# STAFF DEVELOPMENT COMMITTEE REPORT

To: Plan Commission

Project Title: Parkview Apartments Address: 212 N. Dunton Ave.

Setback Diagram: Relationship of Proposed Building to 201 N. Vail

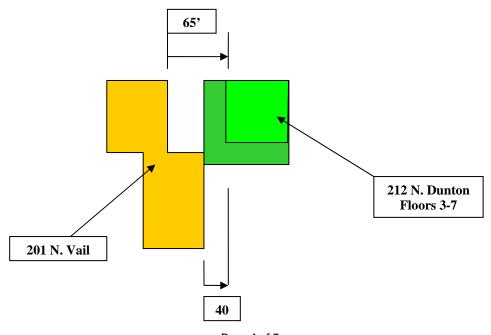
The proposed upper level residential (as measured at the southwest corner of the building) will be approximately 40 feet from the nearest corner of the 201 N. Vail Building. When compared to other developments in the Downtown, the Village Green on Vail Avenue building is approximately 39 feet at its closest point from the adjacent Village Green-Campbell Courte Building.

Downtown developments are required to provide a rear yard setback for residential uses located above the first floor that is no less than 30 feet in depth, which would be the required setback from the west property line. Pursuant to the site development plans, the proposed setback for floors 3 – 7 is 25′ 4″. Staff does not object to this variation as the proposed upper level residential setback along the west property line would provide a building separation of approximately 65 feet from the adjacent 201 N. Vail Avenue Building. As previously mentioned, other high quality developments in the Downtown, such as the Village Green Development, have less separation than what is currently being provided by the Parkview development. The petitioner must provide a response to the variation criteria in order to justify the variation.
